CITY OF CODY  
PLANNING, ZONING AND ADJUSTMENT BOARD  
TUESDAY APRIL 27, 2021  
CITY HALL COUNCIL CHAMBERS @ 12:00 NOON

**CITY OF CODY  
PLANNING, ZONING AND ADJUSTMENT BOARD  
STAFF REPORT**

<b>MEETING DATE:</b>	APRIL 27, 2021	<b>TYPE OF ACTION NEEDED</b>	
<b>AGENDA ITEM:</b>		P&Z BOARD APPROVAL:	
<b>SUBJECT:</b>	PRELIMINARY PLAT OF THE MUSSER-BEACON HILL COMMERCIAL SUBDIVISION. SUB 2021-02	RECOMMENDATION TO COUNCIL:	X
<b>PREPARED BY:</b>	TODD STOWELL, CITY PLANNER	DISCUSSION ONLY:

<b>MEETING DATE:</b>	APRIL 27, 2021	<b>TYPE OF ACTION NEEDED</b>	
<b>AGENDA ITEM:</b>		P&Z BOARD APPROVAL:	X
<b>SUBJECT:</b>	SITE PLAN REVIEW: CODY LOCK UP STORAGE BUILDINGS SPR 2021-19	RECOMMENDATION TO COUNCIL:	
<b>PREPARED BY:</b>	TODD STOWELL, CITY PLANNER	DISCUSSION ONLY:

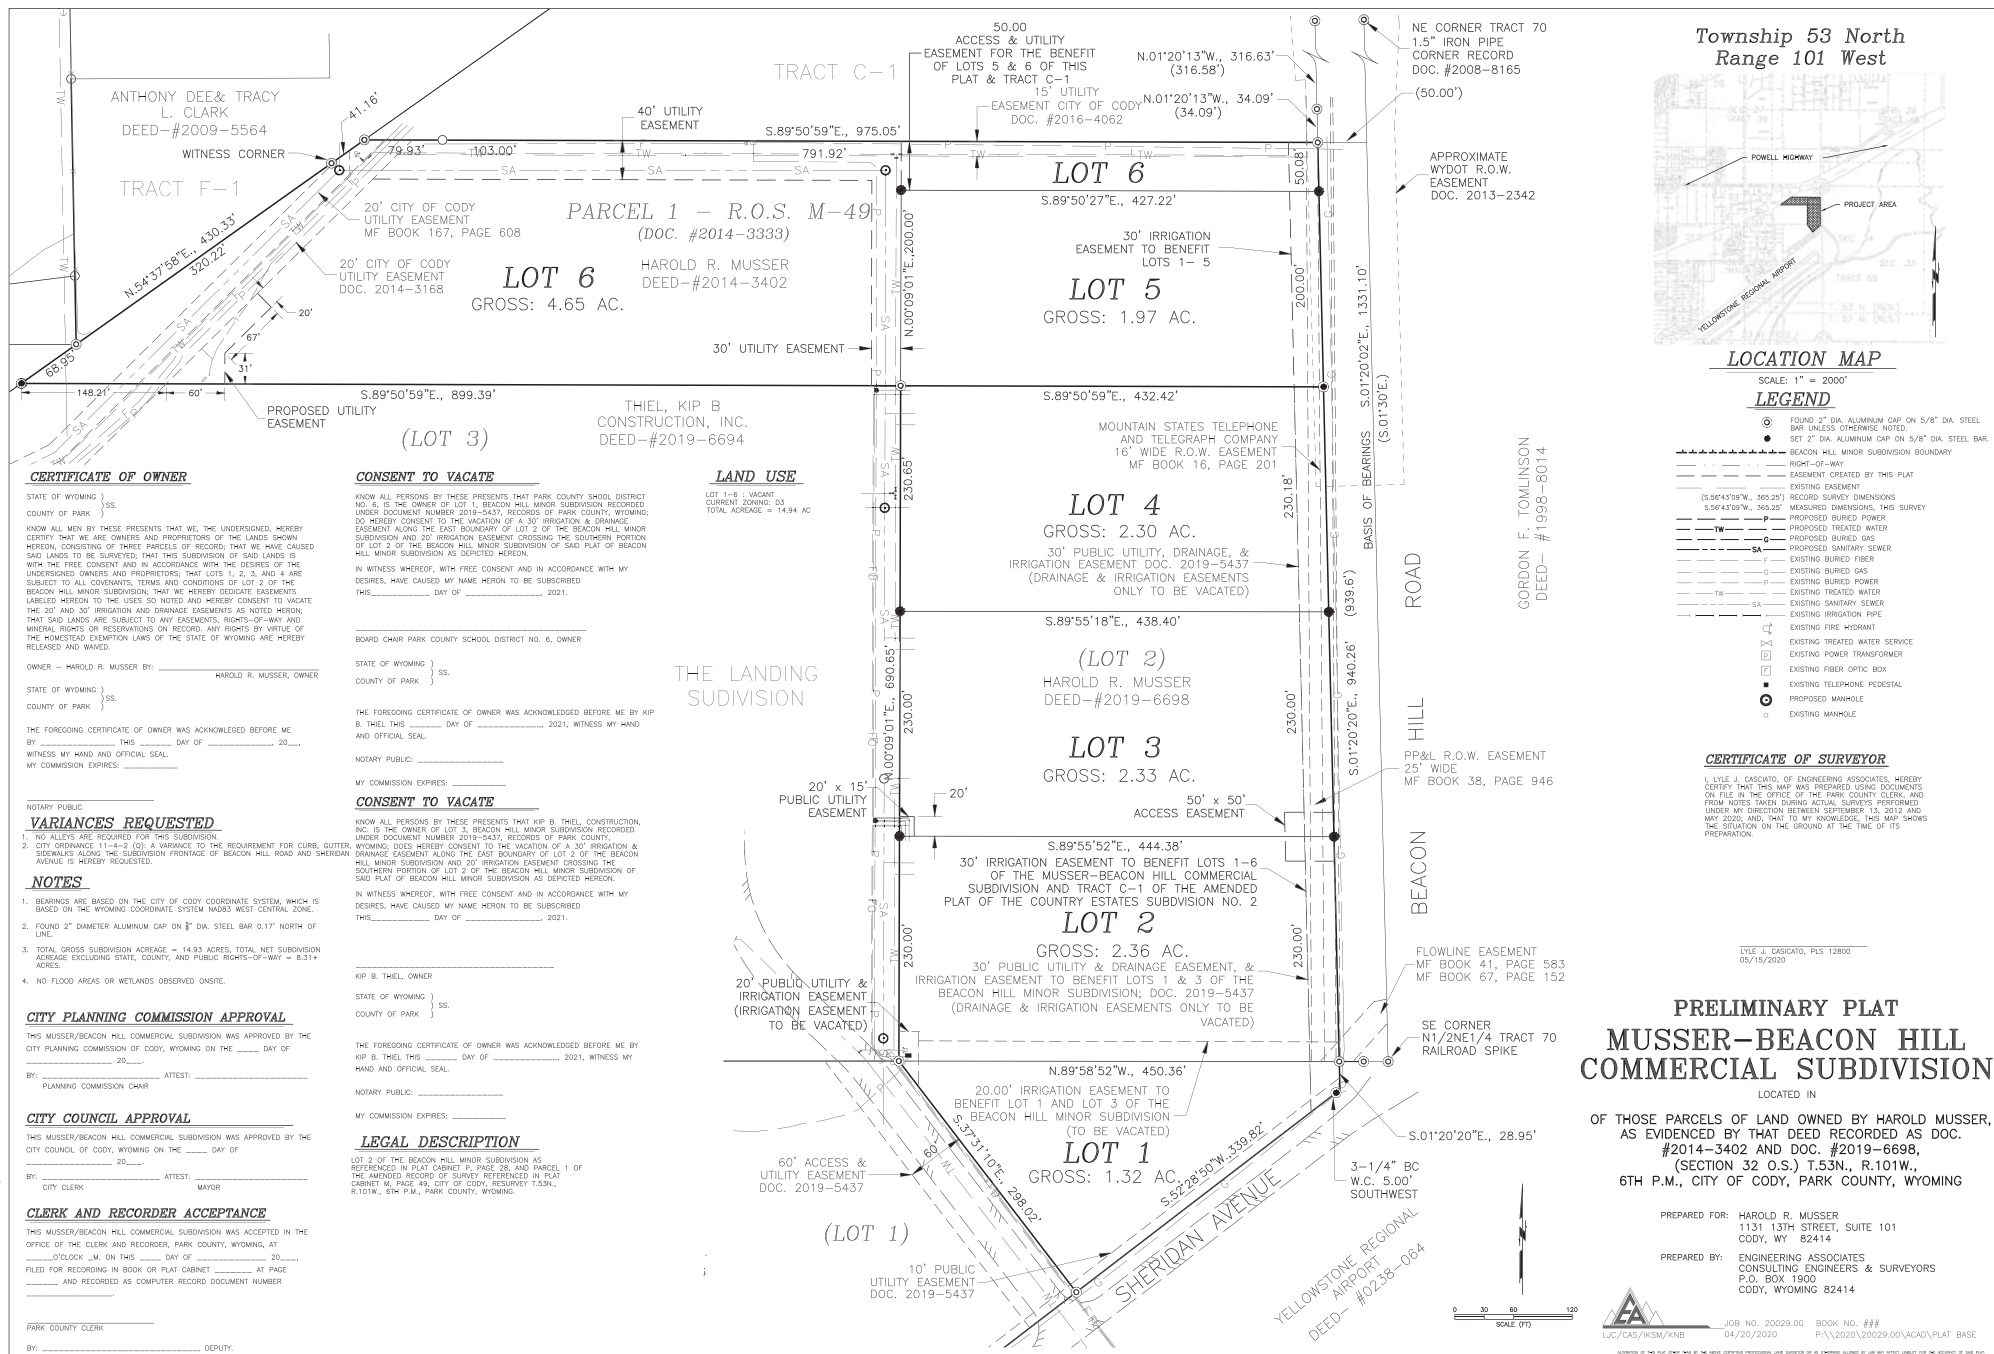
- a) Remove "50.00" from the access & utility easement label north of Lot 5 (or otherwise address the 50.08 dimension and nonparallel borders).
- b) Add the lines/plans for telecommunications/cable.

- e) The third line of the Certificate of Owner should refer to two parcels instead of three.
- f) Is the flowline easement shown SE of Lot 2 still there? (If not, remove.)

- g) Correct the name in the notary block of the School District's Consent to Vacate (it is not Kip Thiel).
- h) Add a note about the fire hydrant/water main installation occurring prior to or in conjunction with development of the lots that will rely on the hydrant, as necessary to address the fire marshal's requirements.

1. Access for Lots 2 and 3 is limited to the 50' by 50' access easement. Add a note to the final plat indicting these restrictions.
2. The Public Use Area requirement is delayed until such time, if ever, that residential development is proposed, and shall be in the form of cash-in-lieu. Calculations shall be made for the lot proposed for residential development, based on the land value and City code requirements then in effect. Add a note to this effect on the final plat.

3. With the final plat application, provide an irrigation water distribution plan and approval of the plan by the irrigation district.
4. With the final plat, provide verification from Cody Canal that they consent to the vacation of the drainage easement and irrigation easement.

5. Develop a plan for installation of the additional hydrant with the fire marshal. Submit the agreed upon plan with the final plat application. The hydrant must be installed prior to development on the affected lot(s) that rely on the hydrant to meet code.

6. Make the corrections/edits to the preliminary plat noted in the staff report, and carry them forward to the final plat.
7. The final plat application and construction documents shall otherwise comply with the City subdivision ordinance. Include a title report/search to verify that all applicable easements and other encumbrances are identified.

SHEET #  
**C1.0**  
SITE PLAN

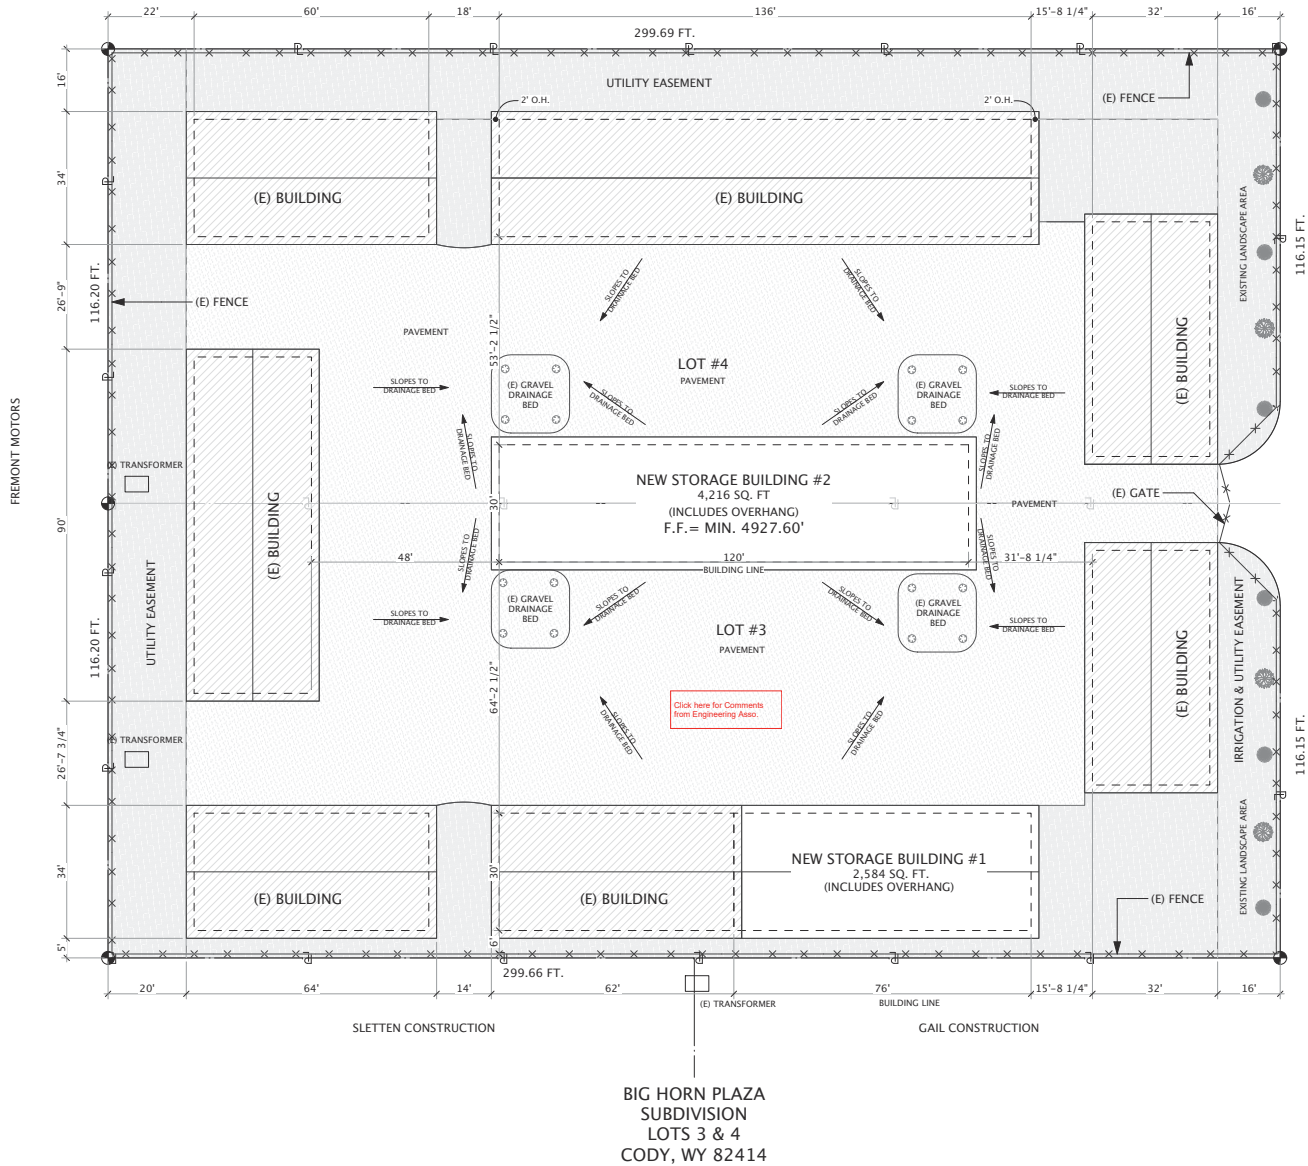
1. Keep the utility easement south of Building 1 free of any A/C condensers or similar fixed equipment.
2. The project must otherwise comply with the submitted site plan and applicable building, fire, and electrical codes. This authorization is valid for three years. If building permits have not been obtained for all buildings by that time, the authorization of the remaining construction will automatically expire—requiring reapplication.
3. (Any lighting conditions? Limit to 3,000 or 4,000 K options? Identify wattage of wall packs.)

TITLE: SITE / GRADING PLAN

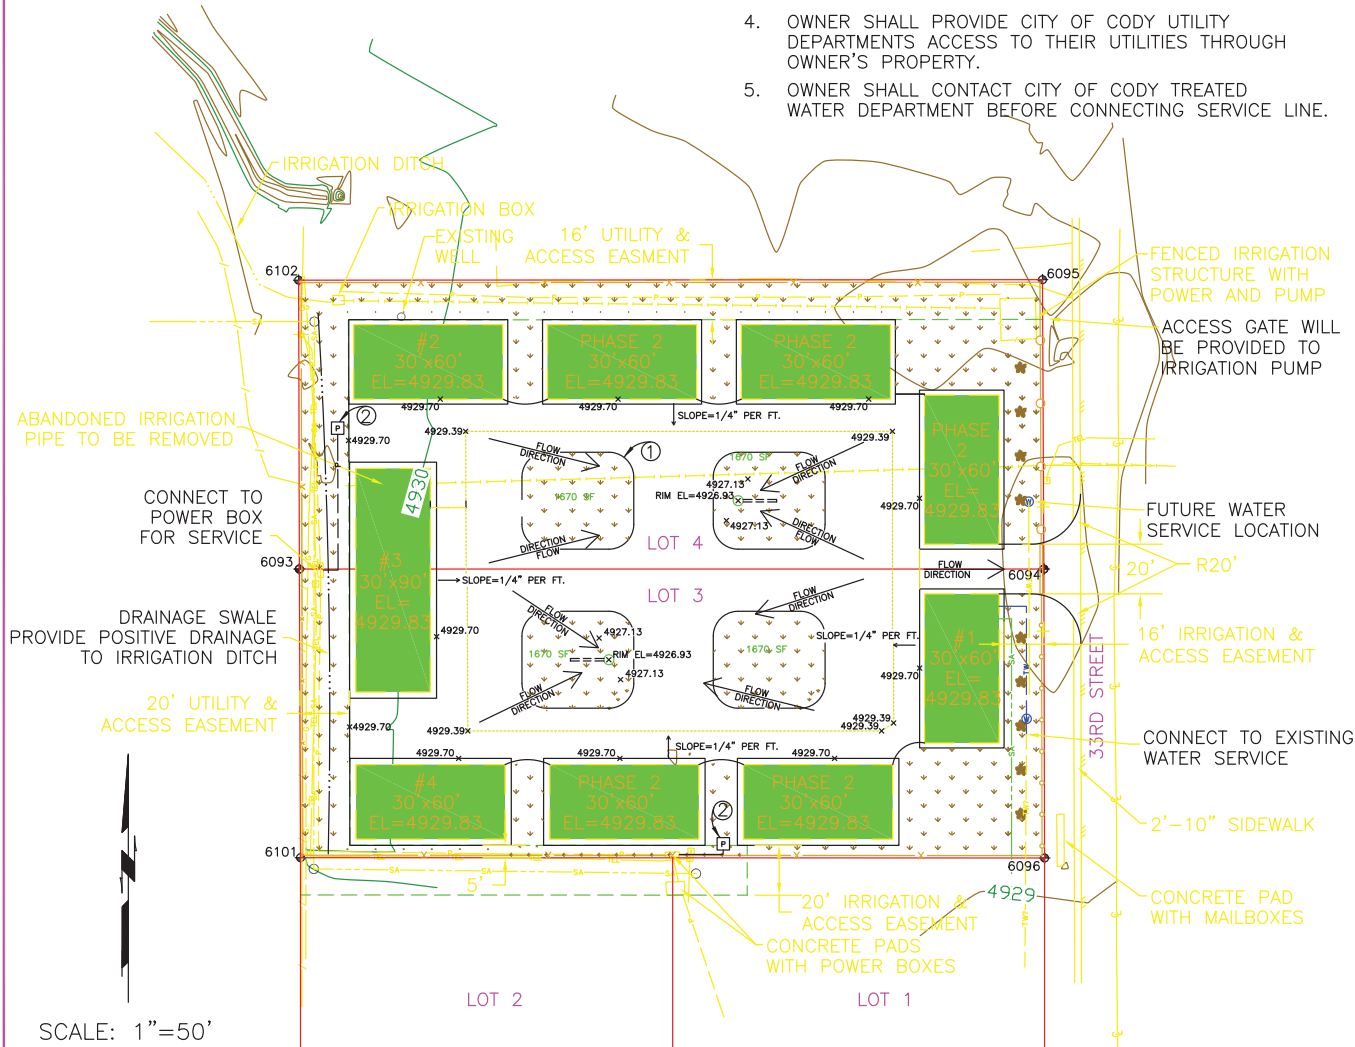
I reviewed our drainage plan. A 100 year, 5-minute event is the worst-case scenario as the system will infiltrate longer duration 100-year events adequately fast to avoid ponding. We need to be able to pond 464 Cubic Feet of water. The two drainage depressions with inlets in them are approximately 1670 square feet each for a total storage footprint of 3340 SF. The stored water depth from a 100-year, 5-minute storm will be a maximum of  $464/3340 = 0.14$  feet deep. The plans indicate that topsoil should be 0.2 feet below the edge of the asphalt. I recommend the finished floor be at an elevation of at least 4927.60 (3" higher than the edge of asphalt at the drainage depressions), but I guess the pavement the building is matching into is higher than that.

There was a prior drainage report and plan prepared for this property and the new building needs to be reviewed for impacts to that plan, and we need to be sure the new building is above the 100-year, 2-hour storm elevation of any water ponding in the middle of that property. The prior report was done by Engineering Associates, Job No. 06011. I have a copy, but you can get it directly from them. I suspect that it will be relatively easy for them to analyze the impacts of the new building and give direction as needed.

The prior storm water plan was reviewed and found adequate for the current proposal. It was also verified by calculation that the 100-year storm event would not overflow the existing swales and cause flooding of the middle building (proposed building #2).
